NC ANG Security Forces Building
Charolotte, NC

Addendum 01

New Security Forces Building

for
North Caroline Air Nation Guard
124th fighter wing
Charlotte, NC

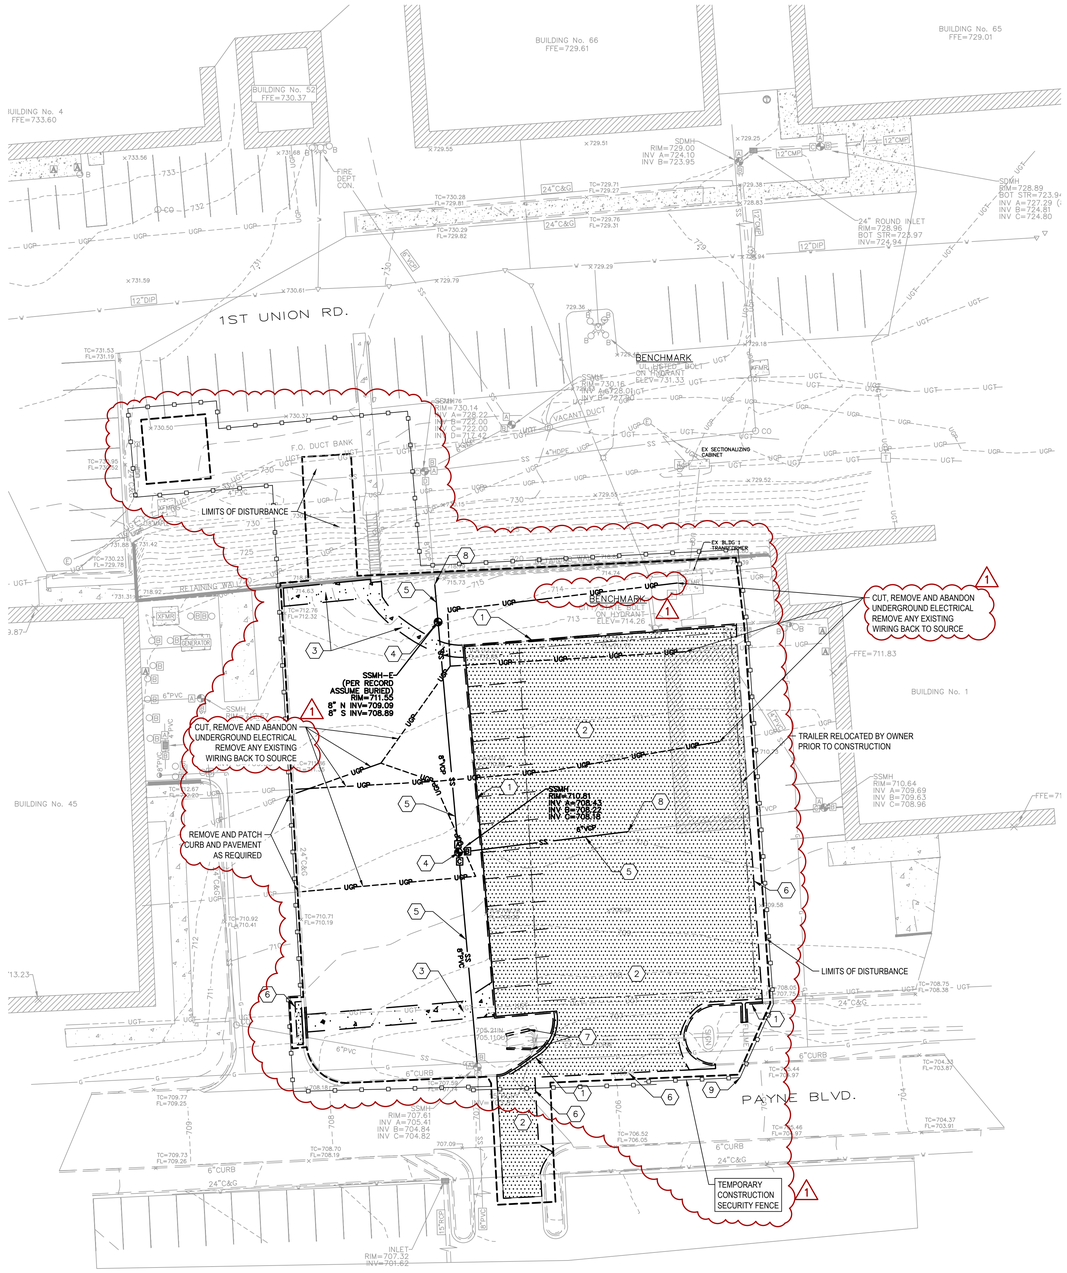
1. Drawing G001 ABBREVIATIONS, LEGENDS, & SHEET INDEX
   a. Added Sheet E002
   b. Added Sheet E003
2. Drawing C001 DEMOLITION PLAN
   a. Added temporary construction perimeter fence
   b. Updated Underground electrical removals
3. Drawing C201 UTILITY PLAN
   a. Updated underground electrical
   b. Updated underground telecommunications
4. Drawing S102 STRUCTURAL SECOND FLOOR FRAMING PLAN
   a. Removed reference to OLI#2 near section mark
5. Drawing S303 STRUCTURAL DETAILS
   a. Added labels to Section 3 clarifying which portions apply to the base bid versus OLI#2
6. Drawing E100 ELECTRICAL SITE PLAN
   a. Removed
7. Drawing A680 DOOR SCHEDULE

ELECTRICAL SITE DEMOLITION PLAN

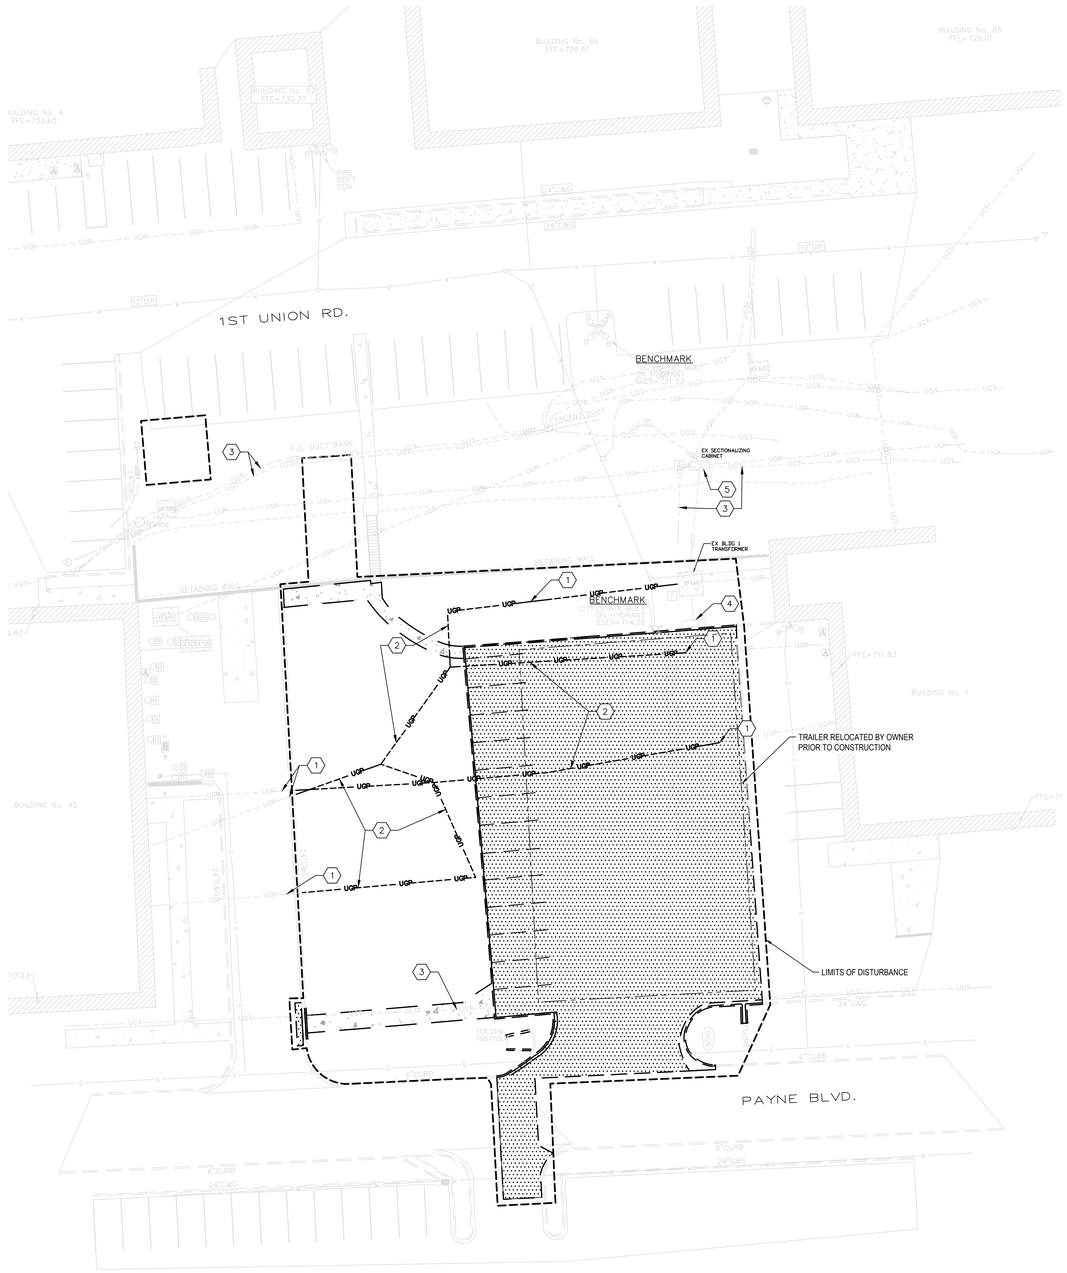
8. Drawing E002 ELECTRICAL SITE DEMOLITION PLAN
   a. Added
9. Drawing E003 ELECTRICAL SITE NEW WORK PLAN
   a. Added
10. Drawing E101 POWER PLAN - LEVEL 1

1
E101

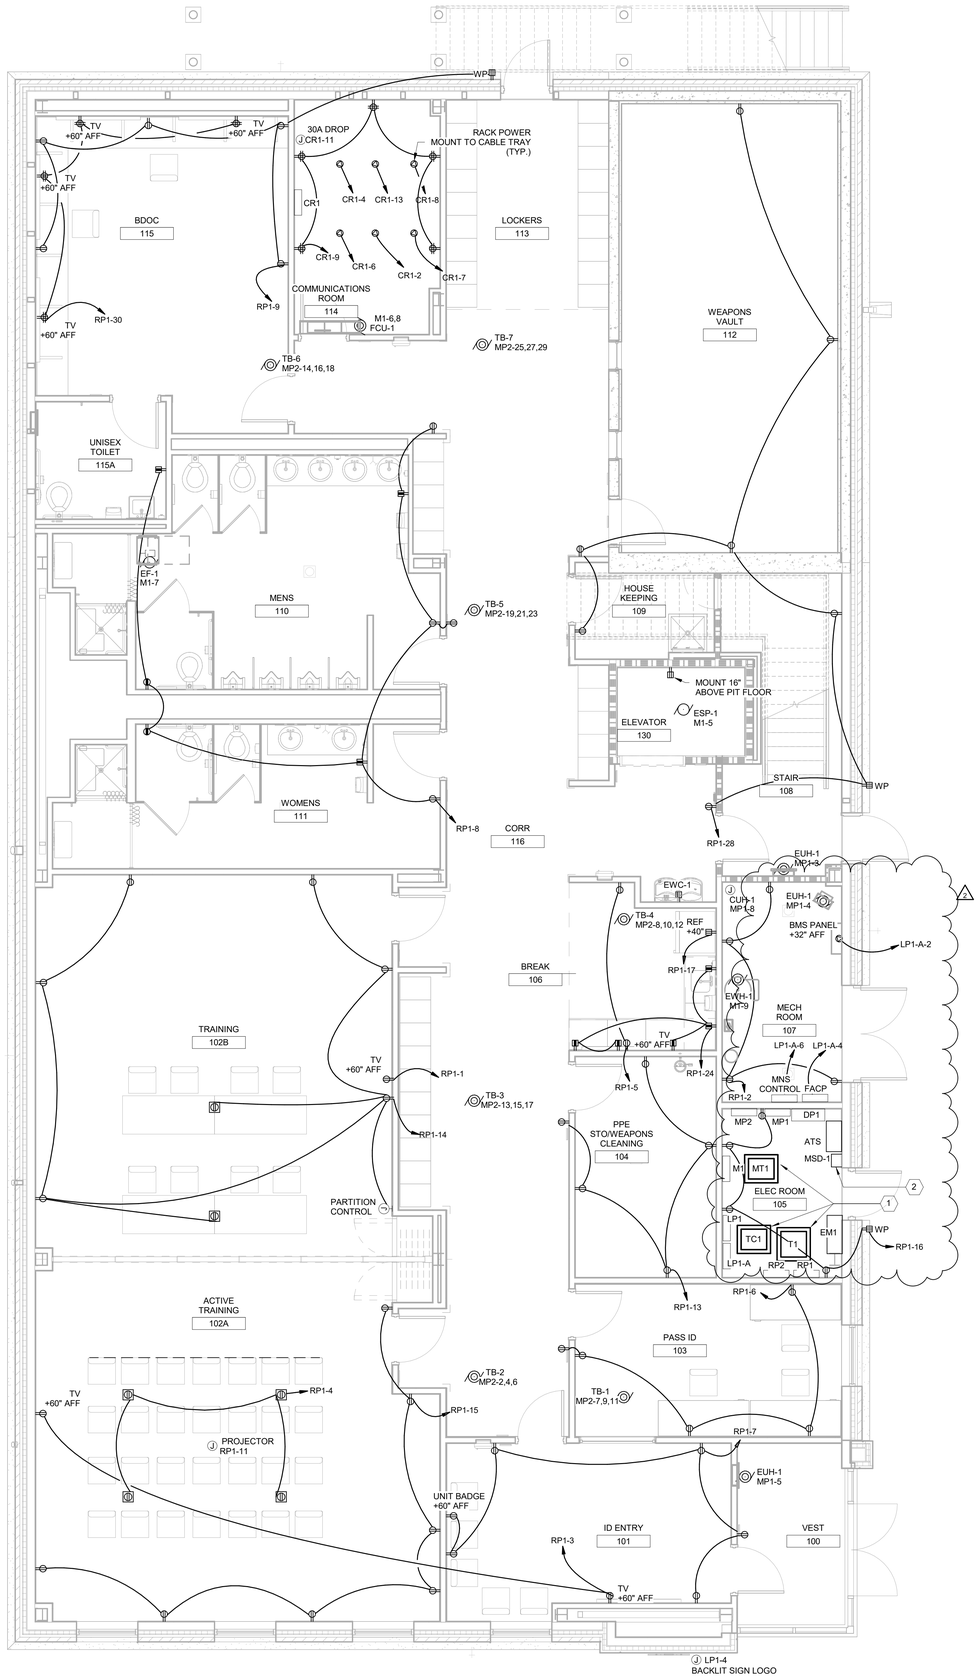
a. Showed branch circuits for control panels in Mech Room 107; Re-arranged Electrical Room 105, called for transformers to be mounted on the wall above their panelboards, moved the Main Service Circuit Breaker, Meter and ATS into the Electrical Room.

1
E102

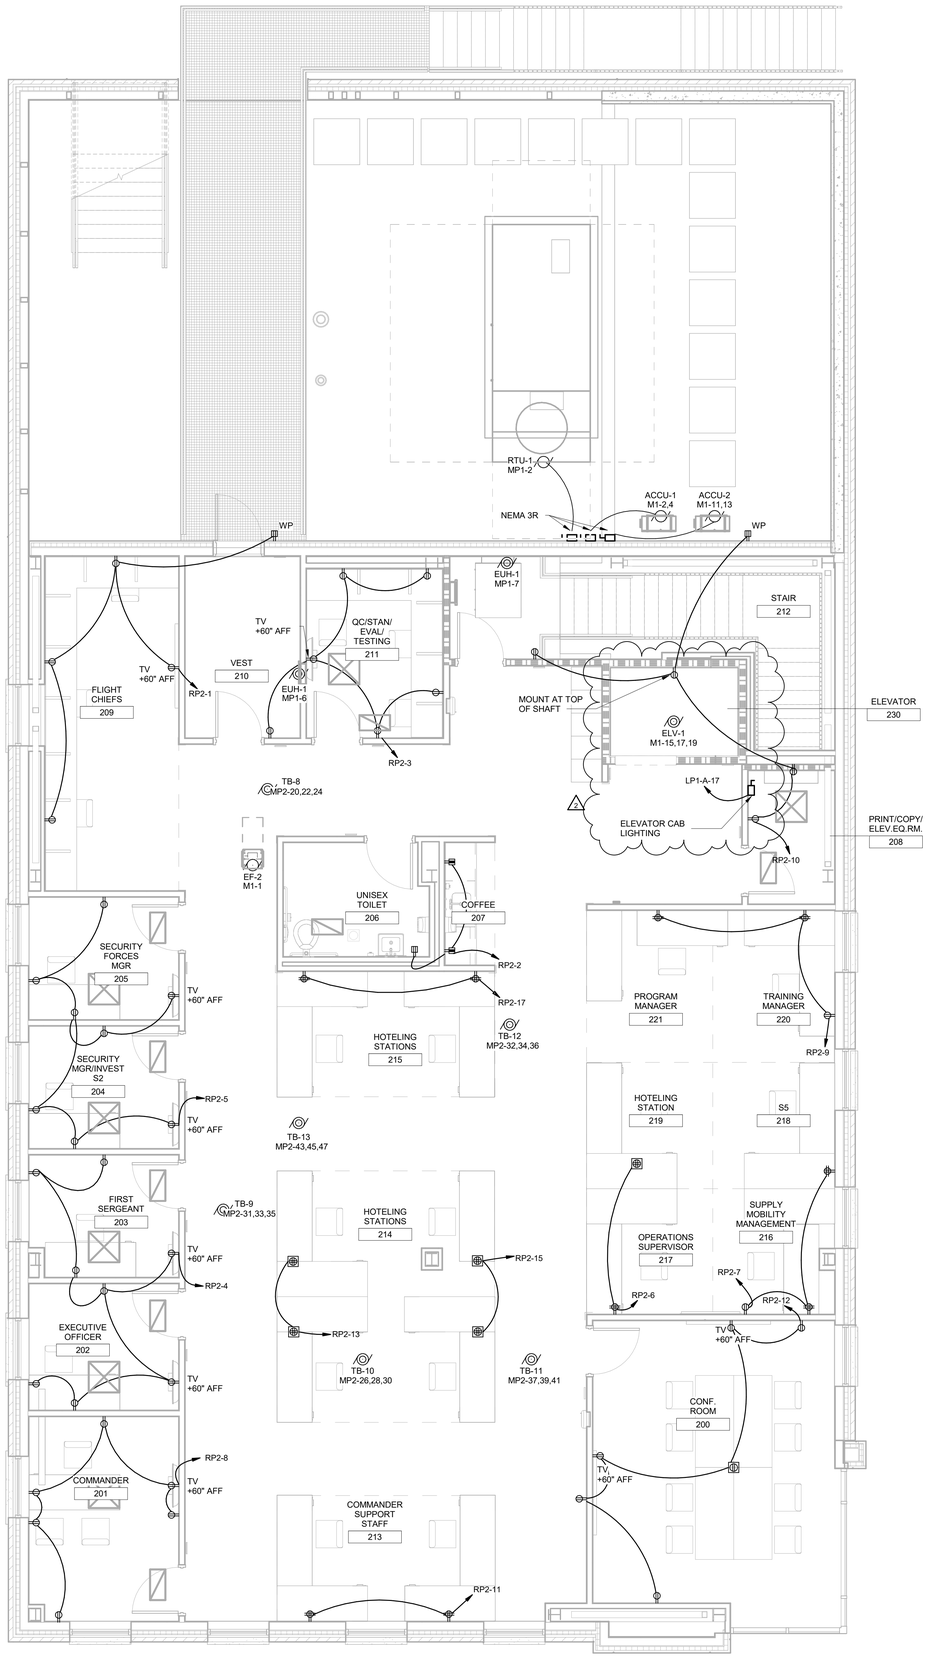
11. Drawing E102 POWER PLAN – LEVEL 2
   a. Showed a disconnect and dedicated circuit for the Elevator Cab lighting, in the Print/Copy/Elev Eq Rm.
12. Drawing E201 LIGHTING PLAN – LEVEL 1

1
E201

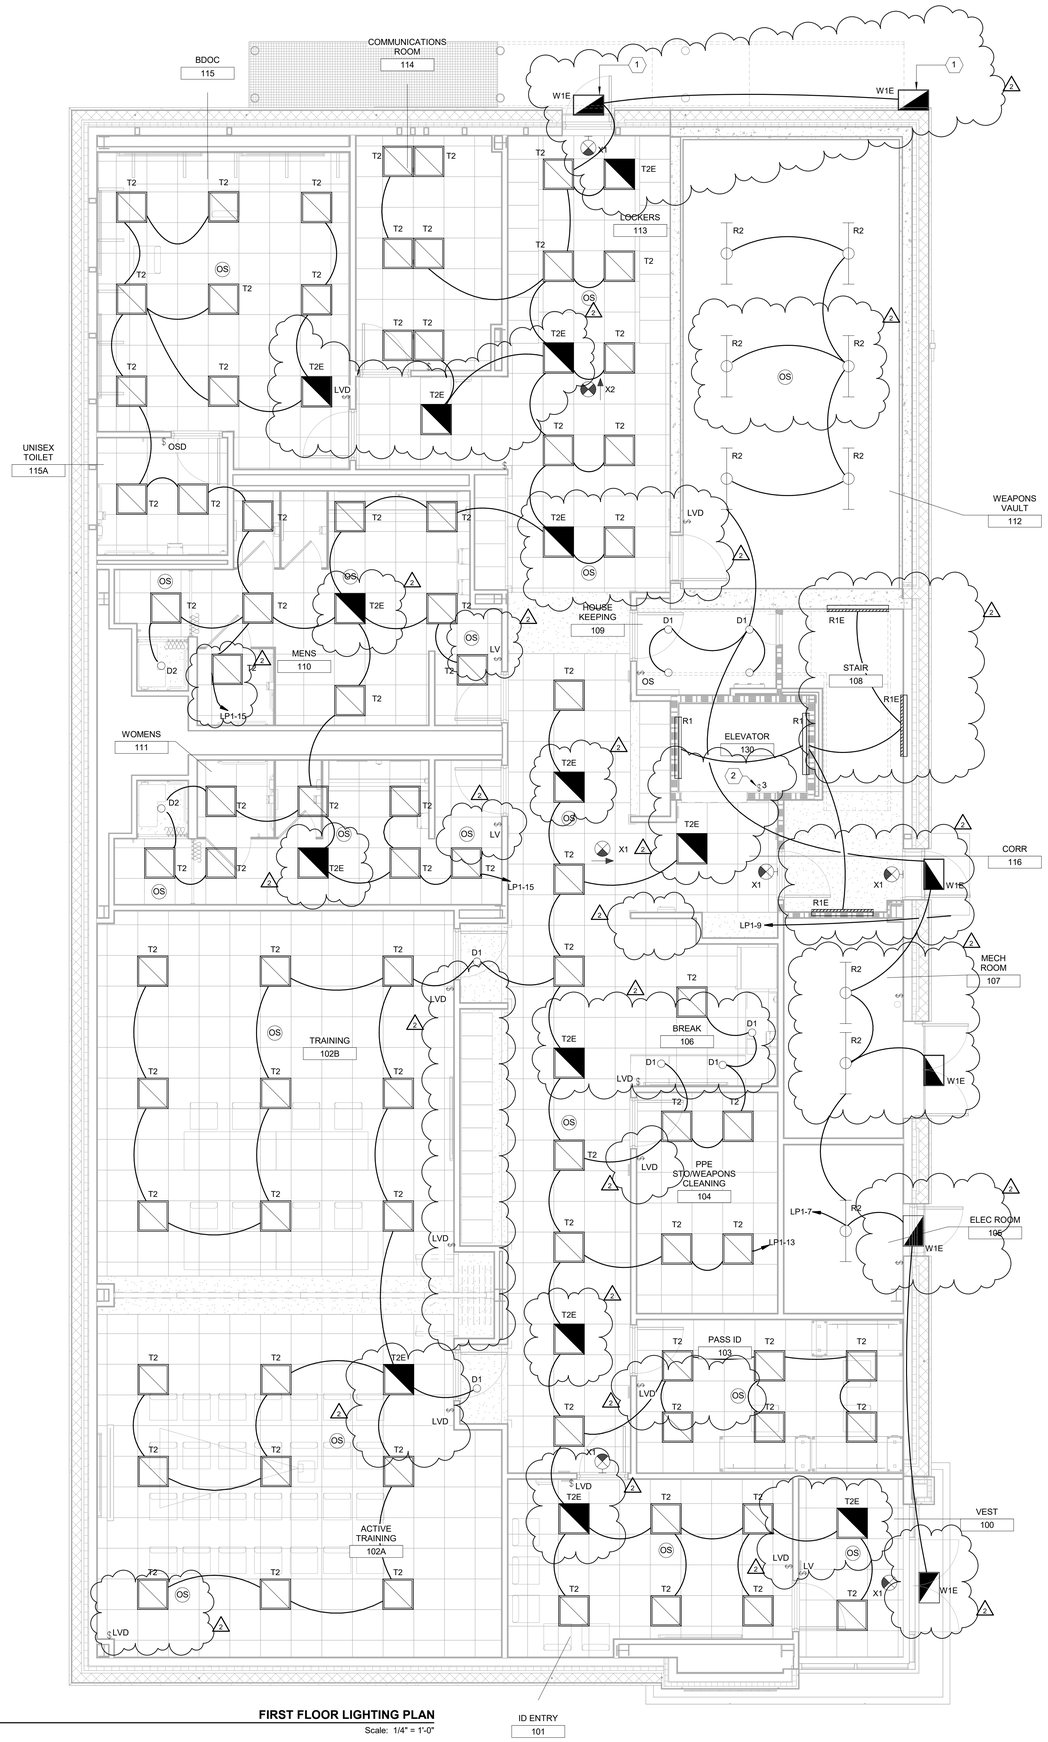
a. updated lighting controls to use a symbol in the legend, and show life safety luminaires with hatching. Deleted downlights that are above lockers. Added occupancy sensors for better coverage. Added move exterior lighting at the north stairs.

1 E202 **SECOND FLOOR LIGHTING PLAN**

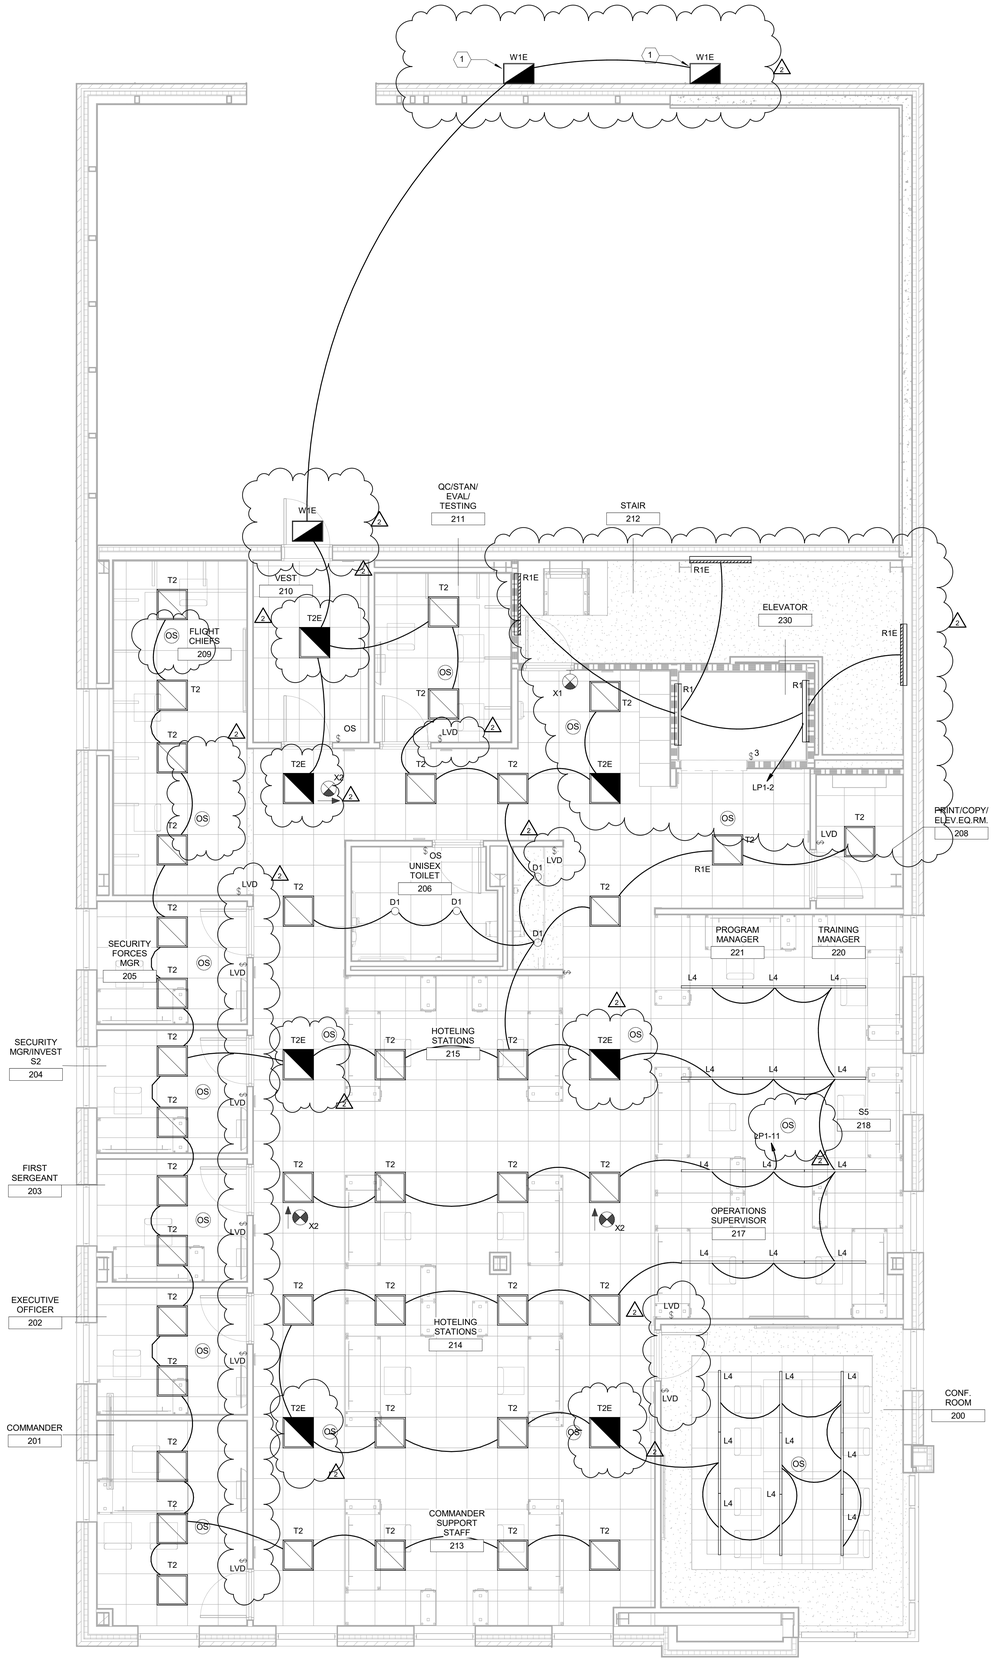
13. Drawing E202 LIGHTING PLAN – LEVEL 2
   a. updated lighting controls to use a symbol in the legend, and show life safety luminaires with hatching. Deleted downlights that are above lockers. Added occupancy sensors for better coverage. Added move exterior lighting at the north stairs.

2 MEDIUM VOLTAGE CONCRETE ENCASED DUCTBANK
E501 NTS

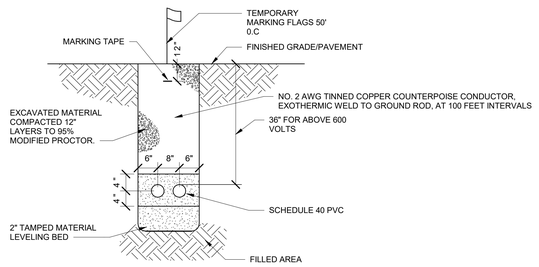
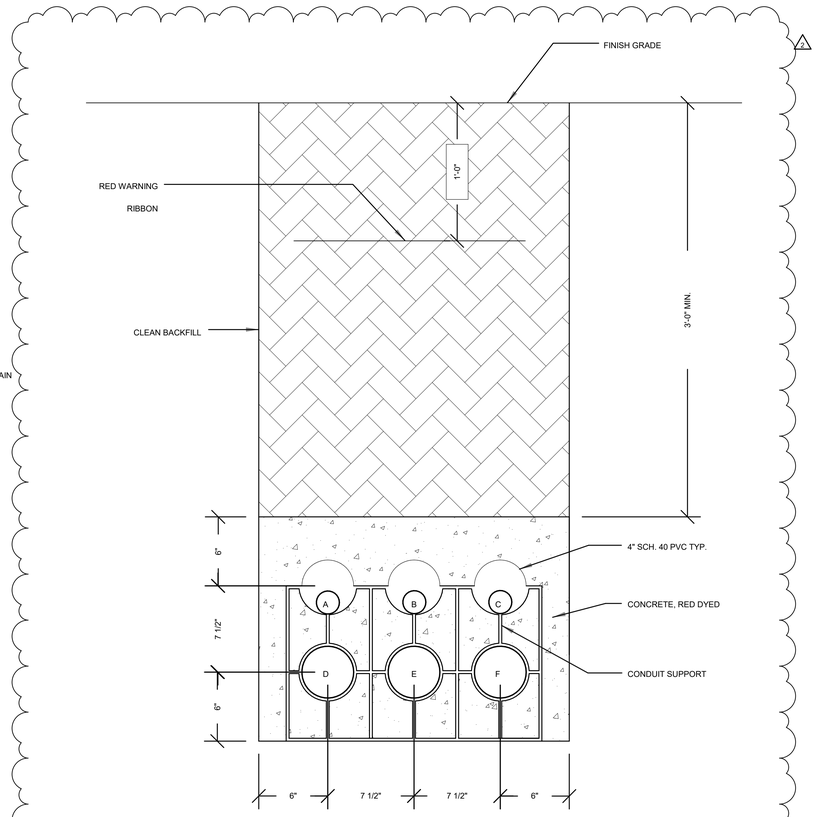
14. Drawing E501 ELECTRICAL DETAILS
   a. update the Concrete Encased Ductbank detail for the Medium Voltage Feeder, removed the Meter Socket detail, added ductbank detail for the Service Transformer Secondaries and Generator to the Building.
